RE: SEDIMENT POND 8

PROFILE SECTION
Dual Spillway and Anti-seep Collar
Sediment Pond No. 8
Getty Mining Co.

RE: Review Comments for Sediment Pond #8, Unit Train-Loadout, Star Point Mines, ACT/007/006, #2, Carbon County, Utah

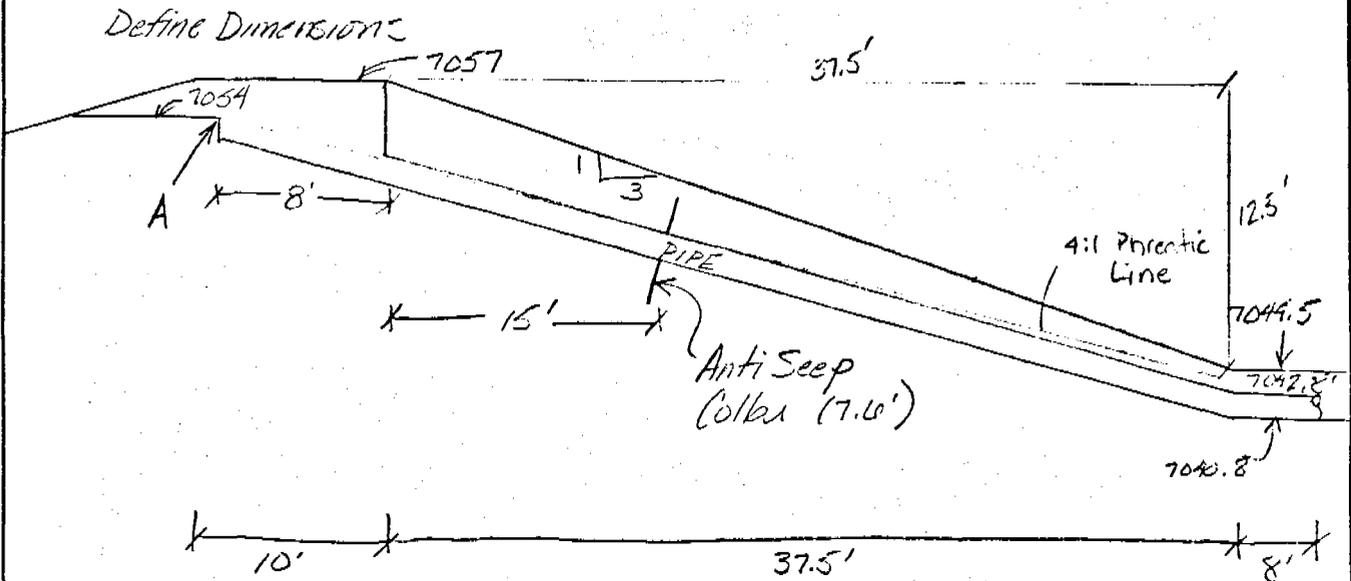
The location and size of the anti-seep collars proposed for the 24 inch CMP conduit must be provided. The Division needs this information to ensure that the flow length will be increased a minimum of 10 percent.

Only one anti-seep collar is needed for the spillway pipeline. The attached drawing (in the Appendix) shows the size and location of the 24 inch CMP anti-seep collar. Calculations are also included in the Appendix. By utilizing the collar, the flow length is increased 10 percent.

Anti-Seep Collar Design

Use 1 collar place collar 15' downstream from concrete structure

Figure 1. Dual Spillway Rating Curve

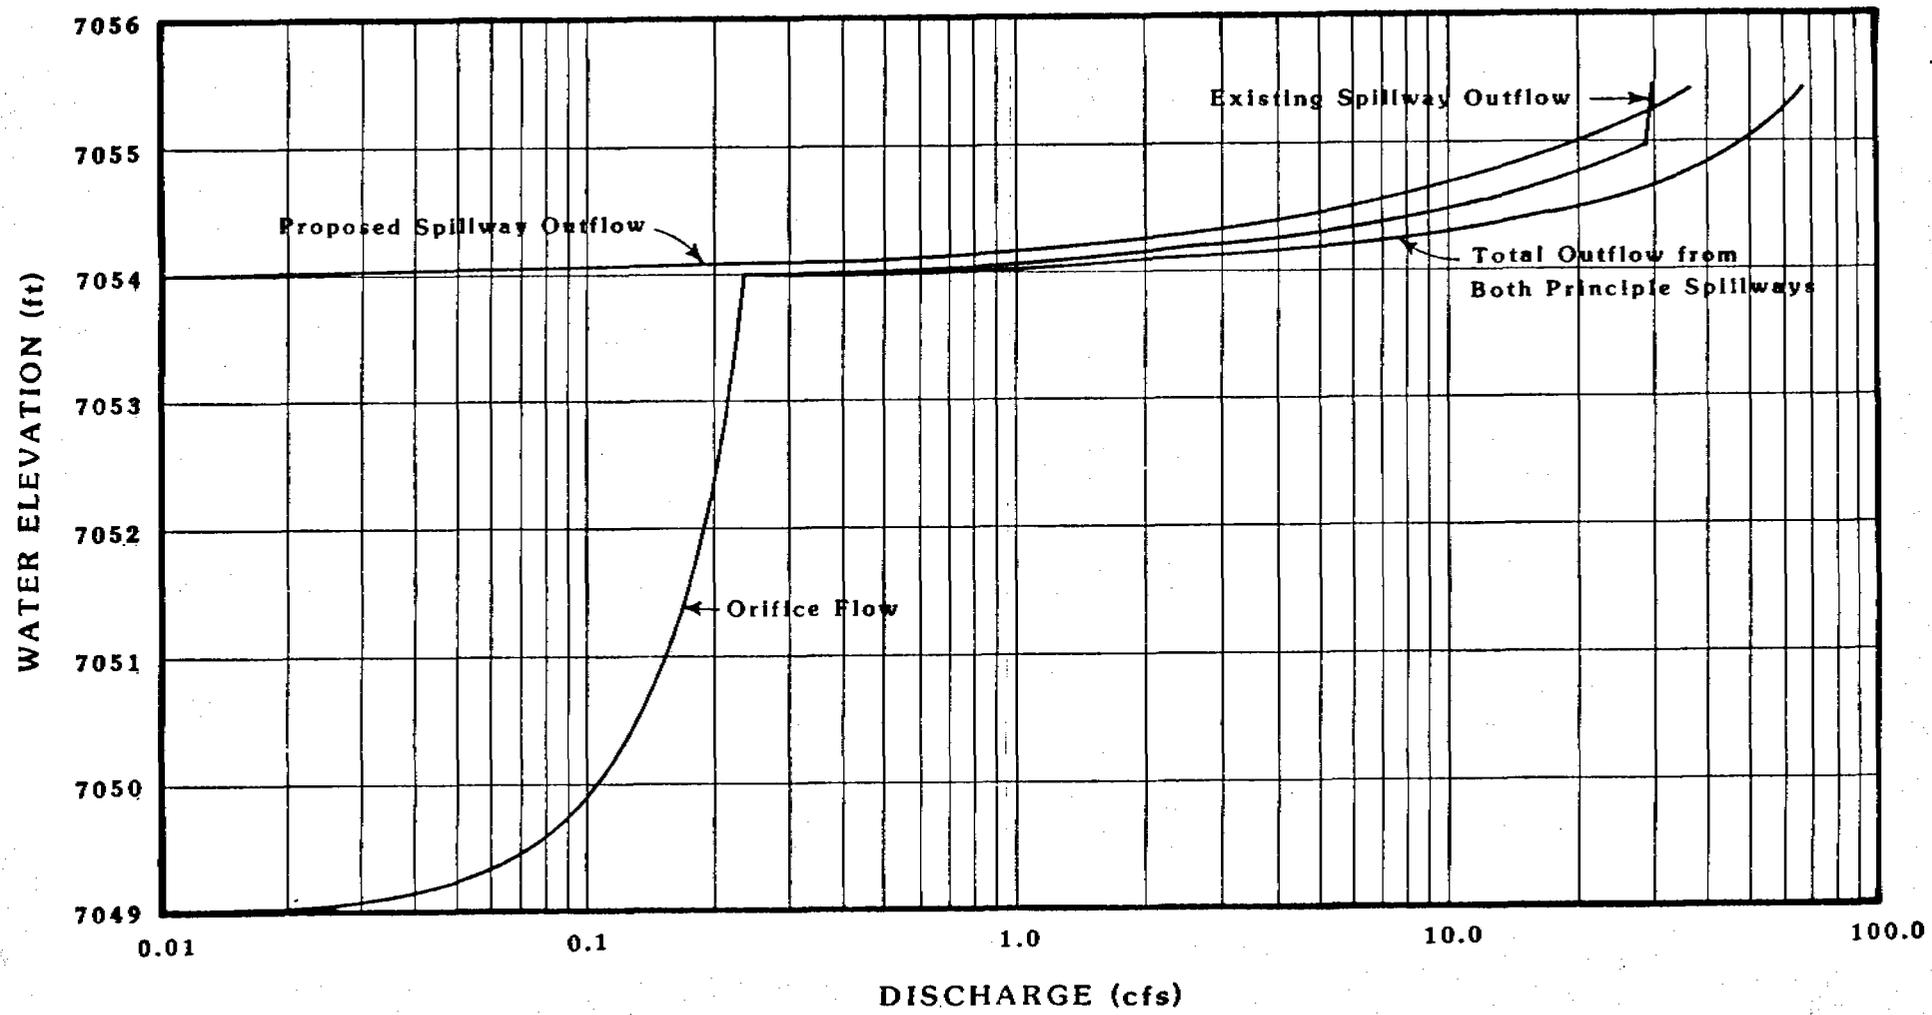
The May 10, 1984 submittal does not provide documentation that the proposed design will be capable of handling the design flow. PMC must provide a spillway rating curve for pond #8 which addresses discharge from the dewatering orifice (if included), the principal spillway, and the emergency spillway. The calculations to determine the spillway rating curve must also be provided.

The dual spillway rating curve for pond #8 is shown in Figure 1. Included in this figure are the rating curves for the existing spillway, the proposed spillway, and the combination or summation of the two spillways. Calculations used in its determination are presented in the Appendix.
